Gatwick Airport Northern Runway Project

Design and Access Statement – Volume 3

VERSION: 2.0

SCHEDULE OF CHANGES

Figure 13. CARE Facility Indicative Ground Floor Plan

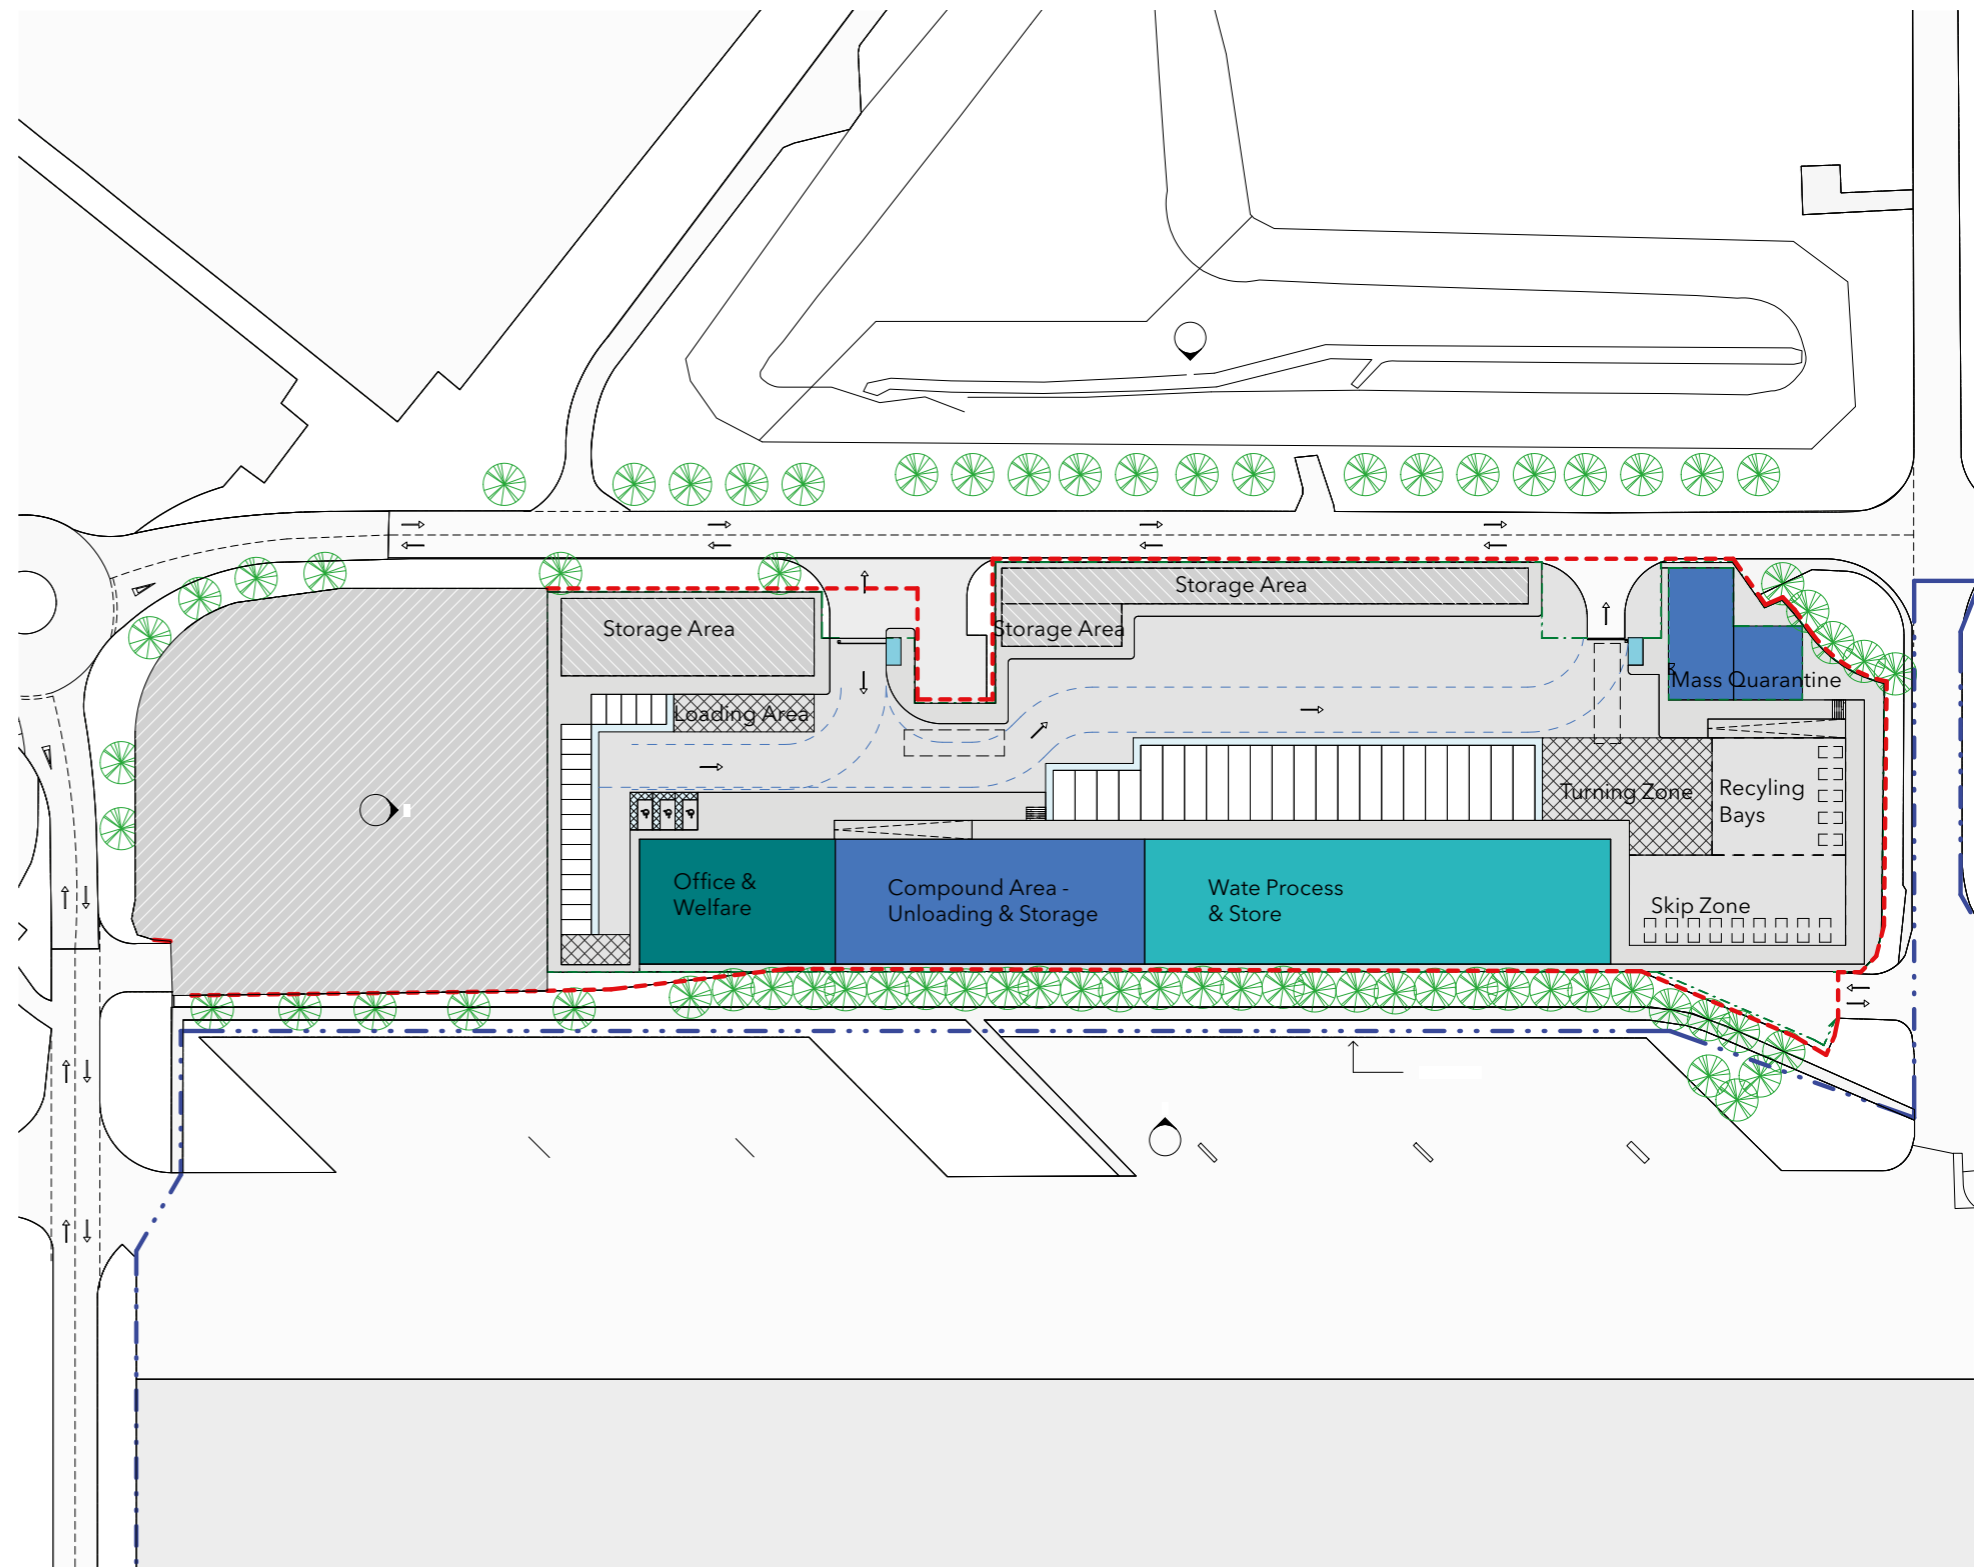
3.6	13	Figure 13	Removal of Biomass annotation.
3.7	14	Figures 14 & 15	Indicative visual changed to reflect that a biomass boiler and associated flue is no longer proposed.

Figure 33. Northwestern Zone - Indicative Building Heights

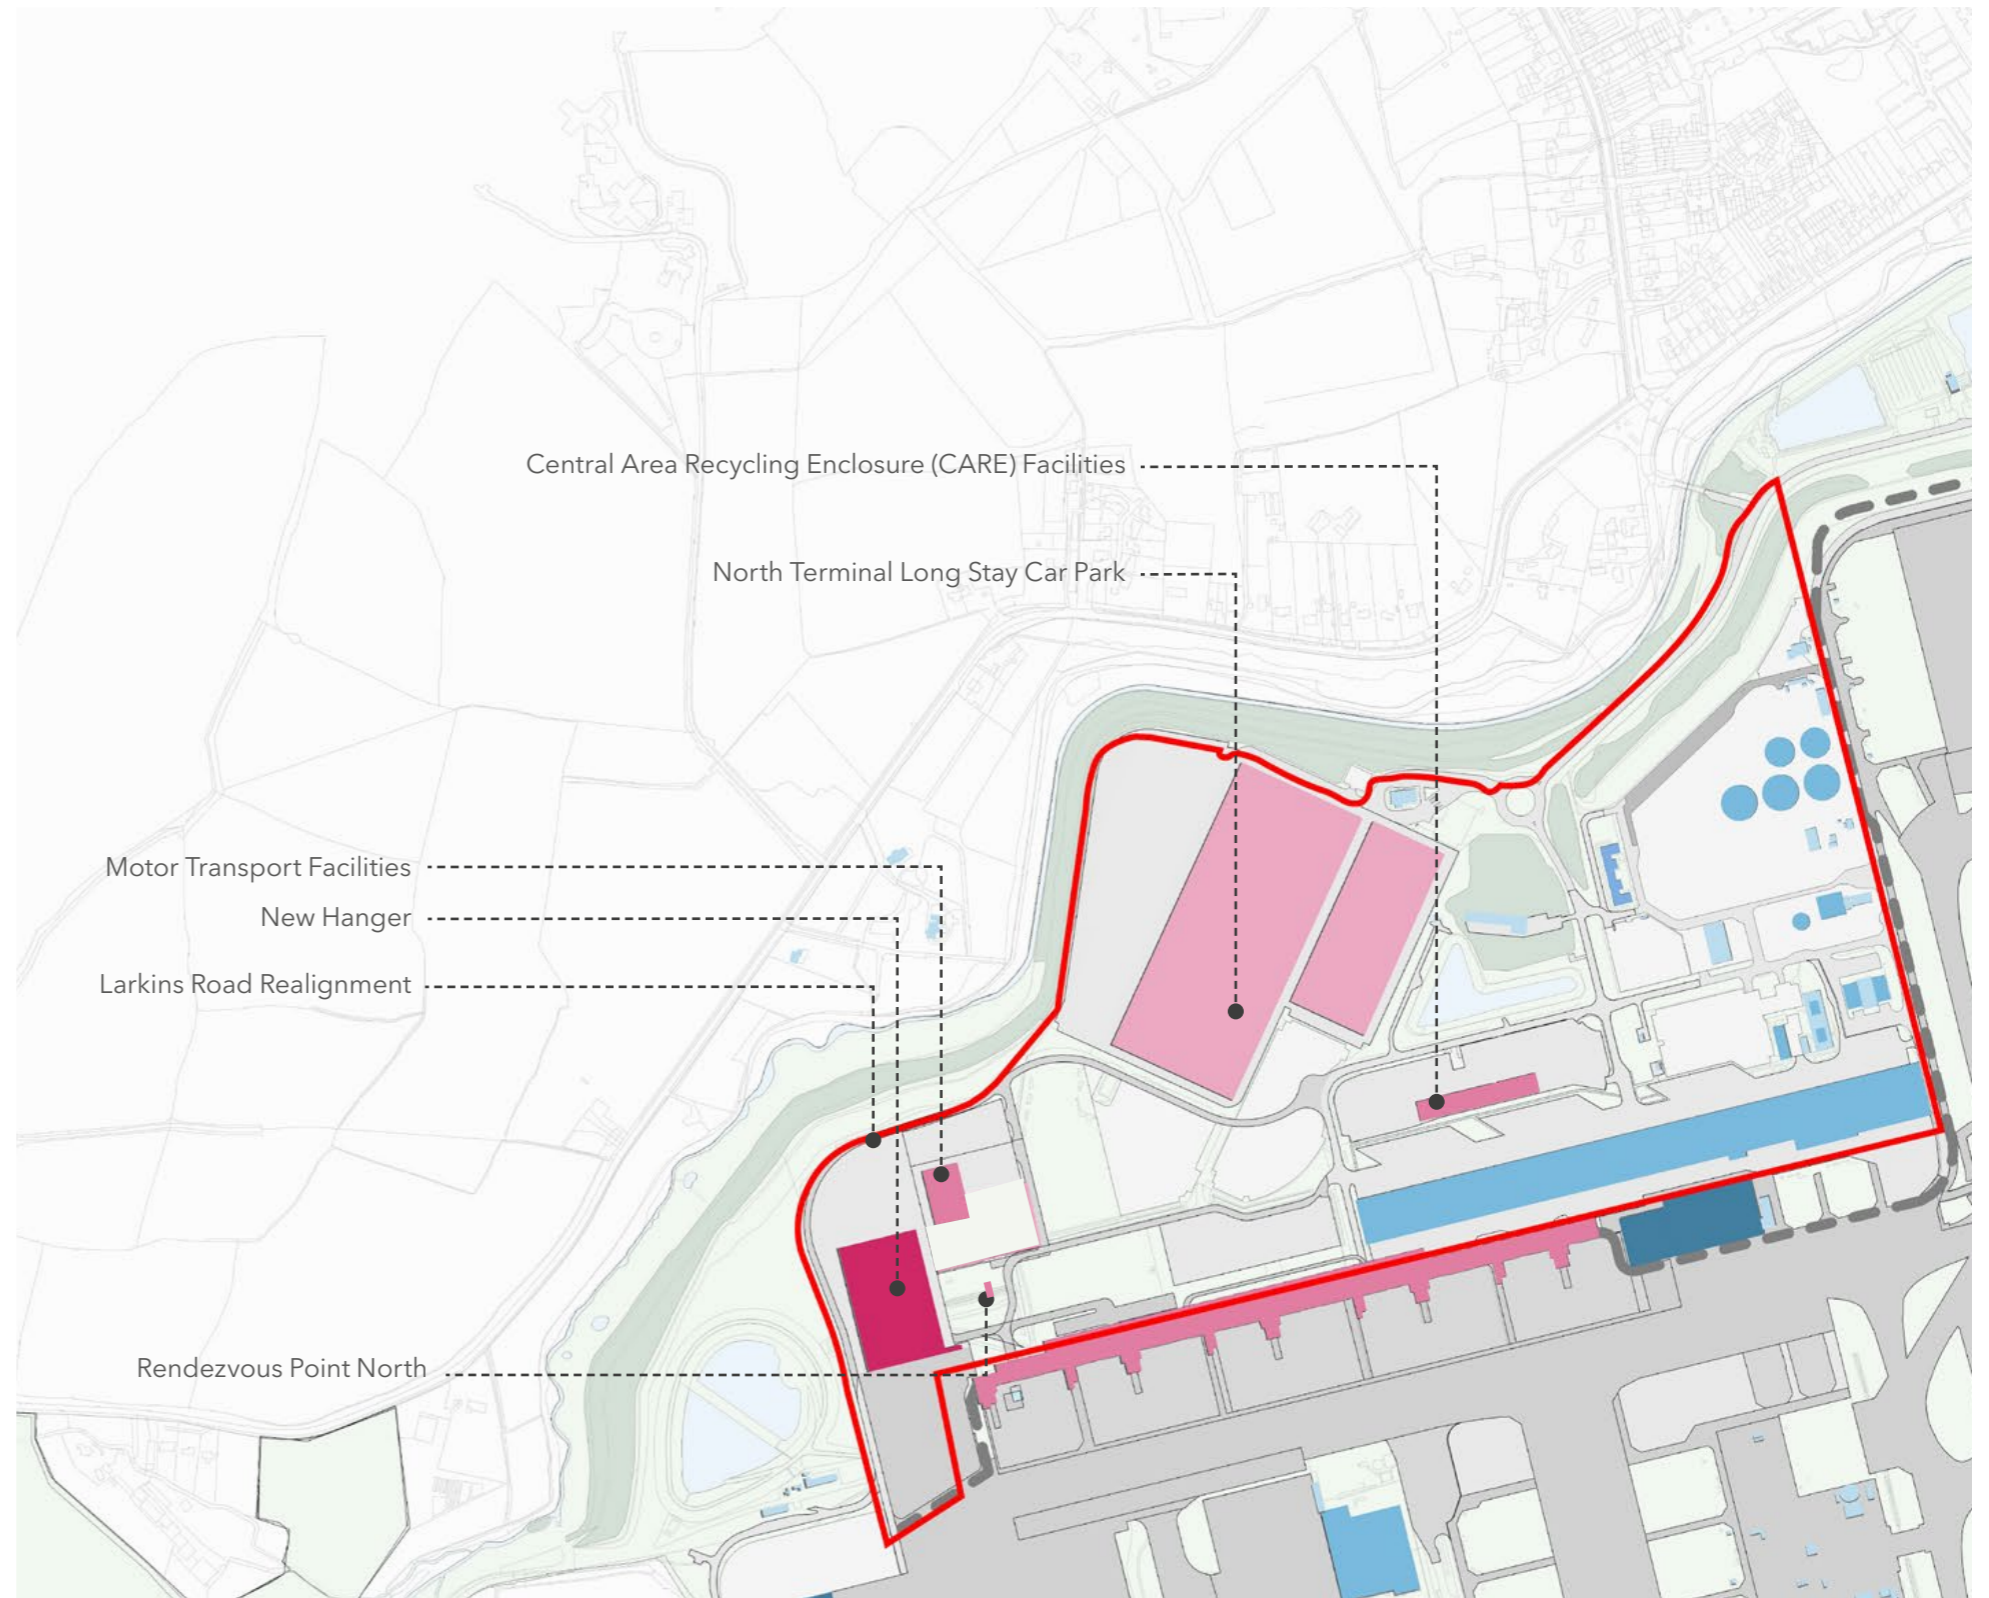
3.10	24	Figure 33	Figure updated to show final phase extent of CARE facility building.
3.11	32	Figure 43	Indicative scope area updated to reflect change to maximum parameter for development.

Figure 48. North Terminal Indicative Scope Location Plan Level 20

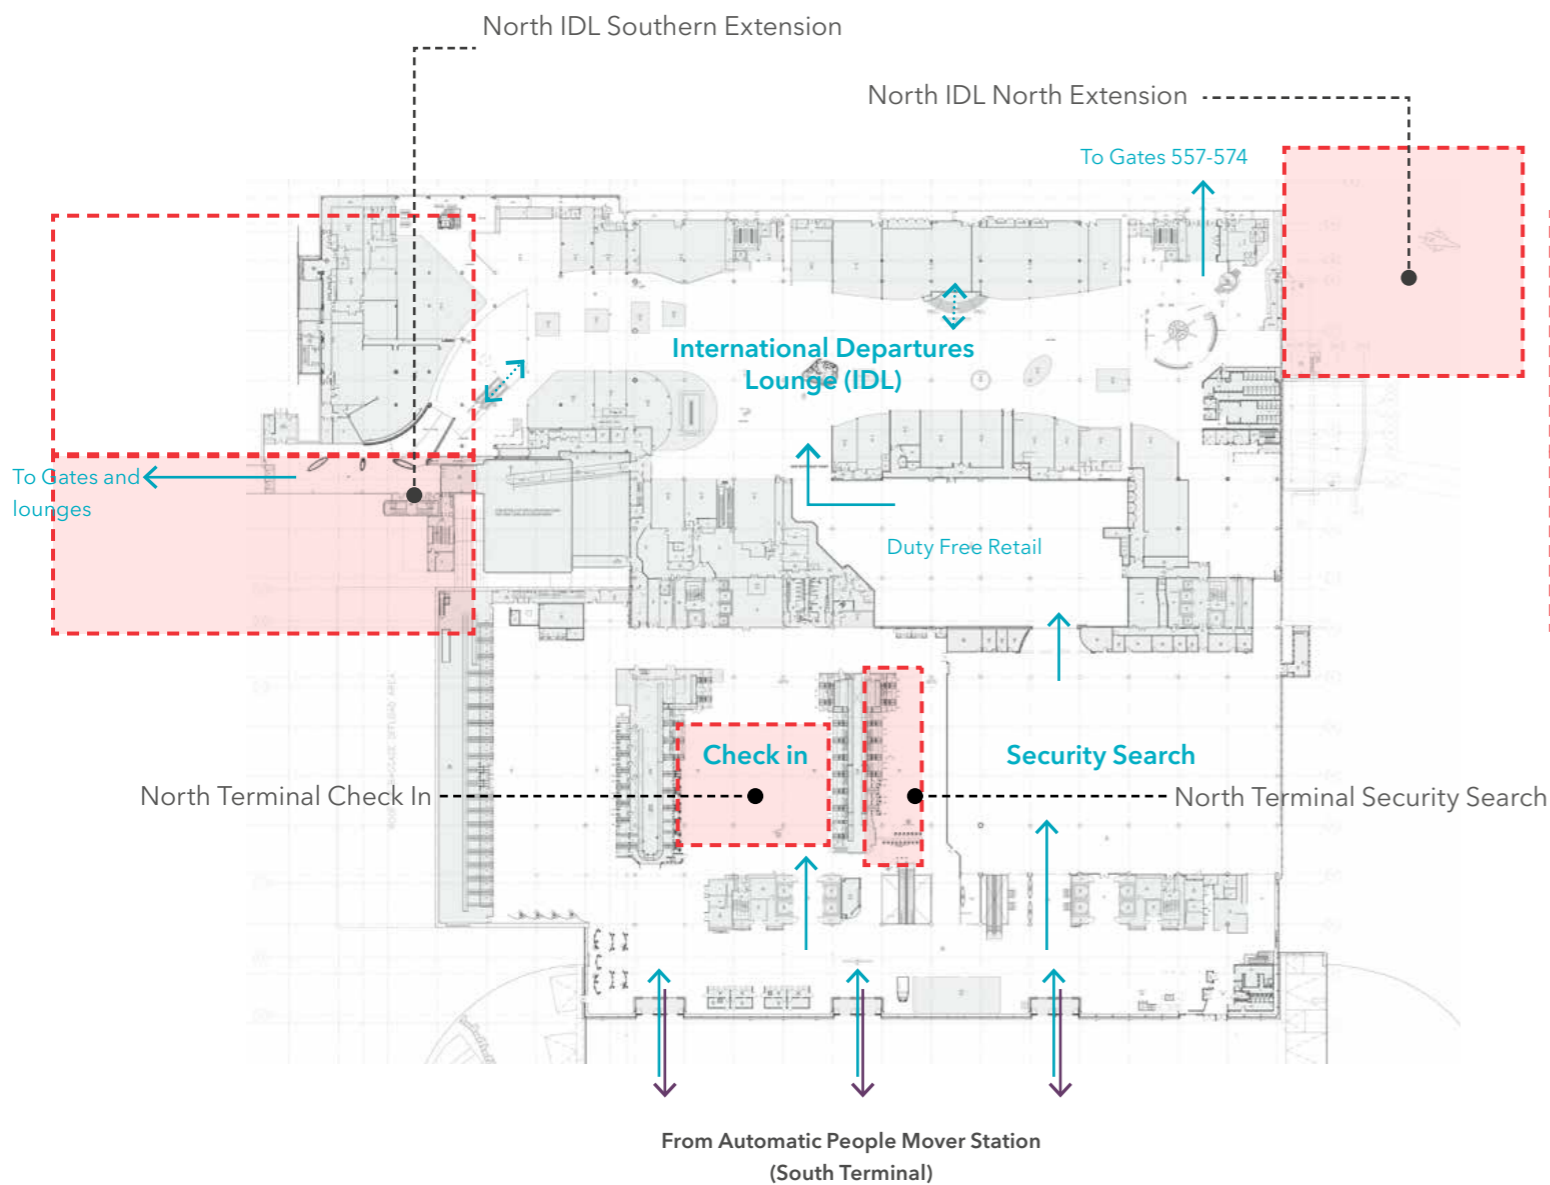
3.12	35	Figure 48	Indicative scope area updated to reflect change to maximum parameter for development.
3.13	35	Figure 49	Indicative scope area updated to reflect change to maximum parameter for development.

Figure 50. North Terminal IDL Extension Site Context Plan

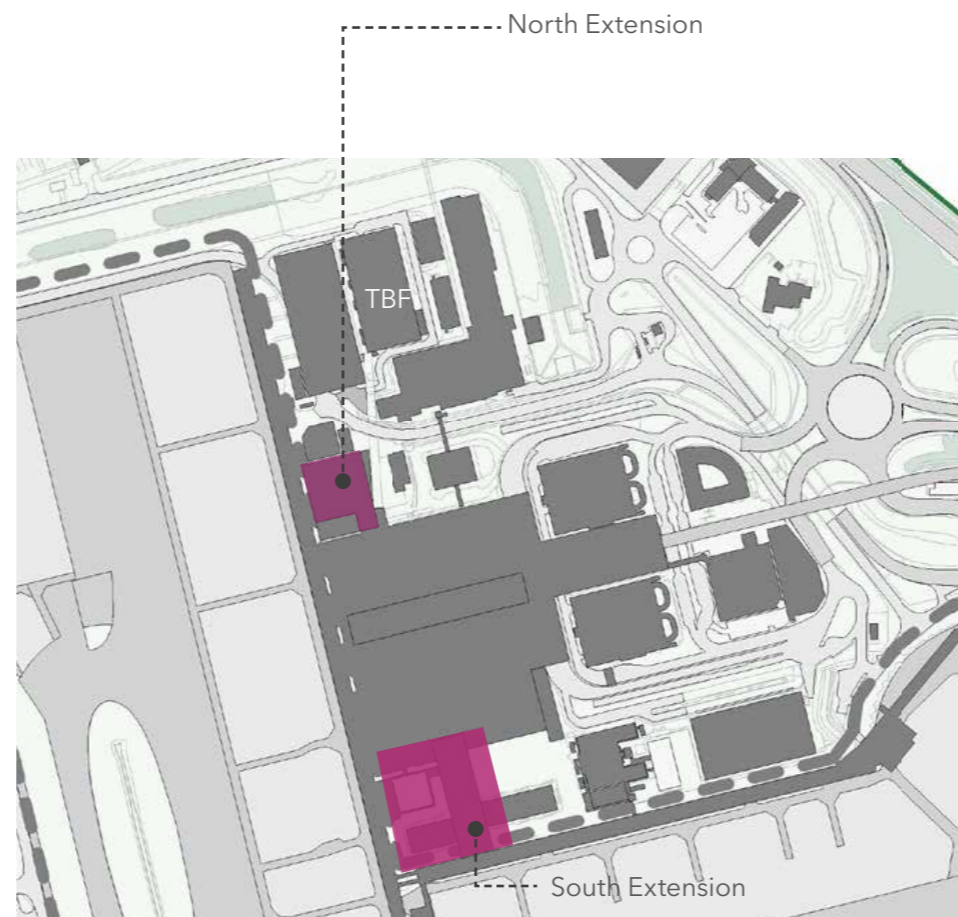
3.14	36	Figure 50	Indicative scope area updated to reflect change to maximum parameter for development.
3.15	39	5.7.6.9	Text updated to reflect change to maximum parameter for development.

Figure 57. Indicative LL20 Plan

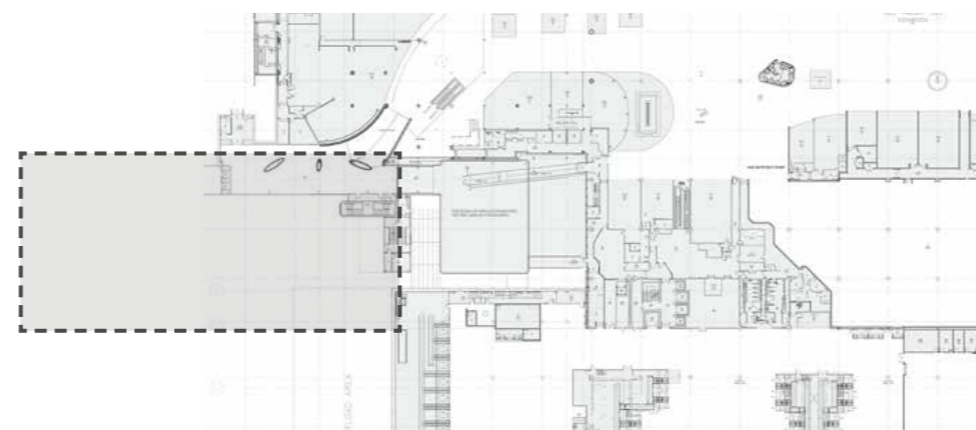
3.17	39	Figure 57	Indicative scope area updated to reflect change to maximum parameter for development.
3.18	40	Figure 58	Figure description updated to include 'Indicative status'.
